Economic Commission for Europe**Inland Transport Committee****World Forum for Harmonization of Vehicle Regulations****Working Party on General Safety Provisions****118th session**

UN Regulation No. 35 (Foot controls)**Proposal for the 01 series of amendments to UN Regulation
No. 35 (Foot controls)****Submitted by the expert from the International Organization of Motor
Vehicle Manufacturers***

The text reproduced below was prepared by the expert from the International Organization of Motor Vehicle Manufacturers (OICA) to clarify the measurement method of the lateral distance of the pedals to the nearest "wall" to the left. It is based on working document ECE/TRANS/WP.29/2019/93, submitted to the 179th session of the World Forum for Harmonization of Vehicle Regulations (WP.29) session and reworked as agreed based on GRSG-117-35 in the 117th session of the Working Party on General Safety Provisions (GRSG) (see report ECE/TRANS/WP.29/GRSG/96, paras. 15-16). The modifications to the current text of UN Regulation No. 35 are marked in bold and strikethrough characters.

Annex 1, item 5, amend to read:

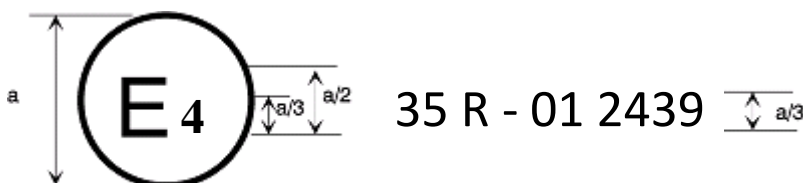
"5. Brief description of the vehicle type as regards the arrangement of foot controls and foot rest....."

Figure 1a

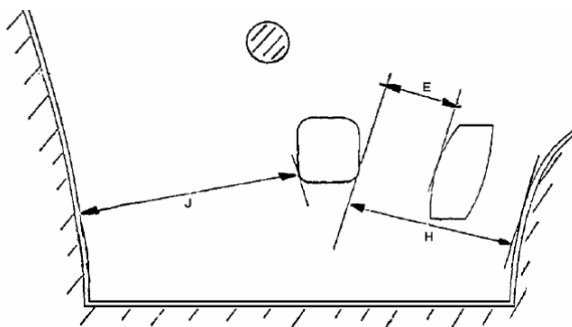
Two pedals – Automatic transmission **without** footrest

<i>max.</i>	<i>min.</i>
E	100	50
H	-	130
J	-	120
K	-	50

Figure 1b

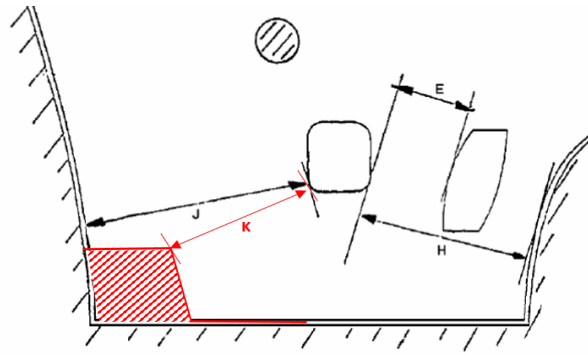
In the case of a foot rest as declared by the manufacturer, installed for the driver's left foot, the measurements for "J" and "G" in Annex 4 shall ignore the foot rest. The distance, shown at "K" in annex 4, between the contour points of the projection of the left most pedal on to plane "P" and the intersection of the footrest with plane "P" shall be ≥ 50 mm."

Two pedals – Automatic transmission **with** footrest

Figure 2a
Three-pedals – Conventional transmission **without Footrest**

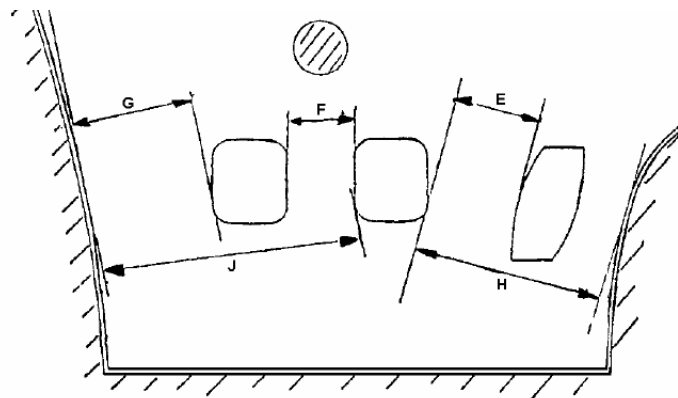
<i>max.</i>	<i>min.</i>
E	100	50
F	-	50
G	-	50
H	-	130
J	-	160
K	-	50

Example for the needed clarification – Measurement of J in 2-pedal system:

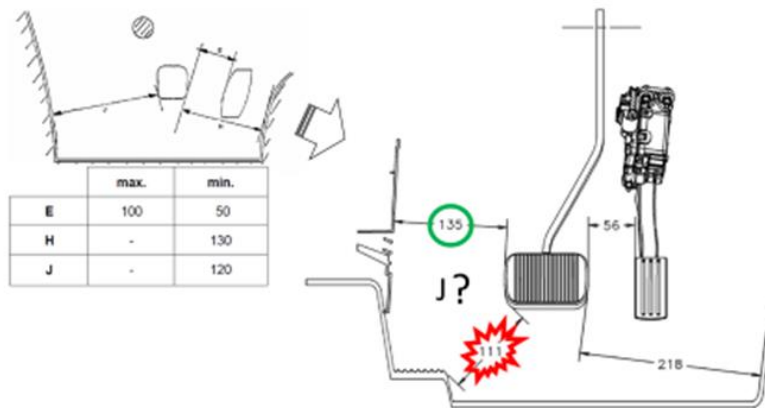
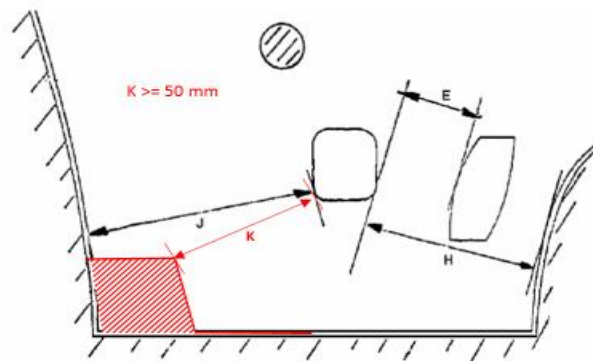
1. Paragraphs 5.5 and 5.6 are amended by adding references to "F" and "G" for clarification.
2. It should be possible to place the left foot in a position of rest on the floor surface or foot rest such that it is not trapped by the pedals. It should also be possible to actuate any pedal over its full travel without inadvertently operating floor-switches or other foot controls.
3. This proposal hence clarifies the measurement method for the lateral distances (J and G) of the pedals to the nearest "wall" to the left. For safety and comfort reasons foot rests are installed for the drivers' left foot. The rest plane of such foot rests can intersect the measurement plane "P". This proposal clarifies that, in such cases, the required clearance for the left foot is measured on top of the foot rest, rather than between the left most pedal and the foot rest itself.

4. To ensure clearance of travel for the left most pedal (either service brake or clutch), an additional minimum distance between this pedal and the foot rest is introduced.

Fig. 1
ARRANGEMENT OF FOOT CONTROLS

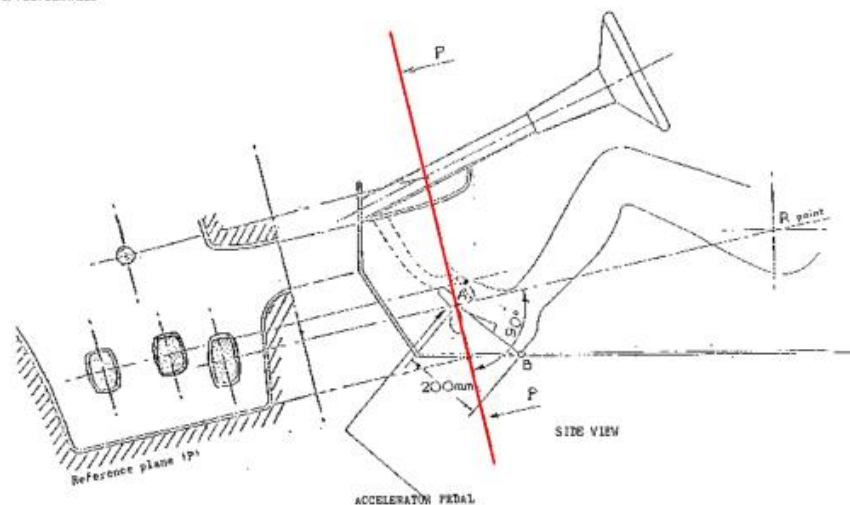
5. Distance K is introduced in Annex 4 for clarification. All measurements for distances to Annex 4 in UN Regulation No. 35 are measured on the reference Plane P. This reference plane is not a vertical transverse plane. The measurements taken on the Plane P are not taken in transverse or horizontal direction, since the smallest distance to left or right is the more relevant. The proposed measuring method for K is in line with other measured distances between fixed and movable parts in the regulation. A projection of the footrest onto plane P would contradict the wording of UN Regulation No. 35 where fixed parts are intersected with plane P. Accordingly in approval drawings foot rests are usually also illustrated as sections with plane P.
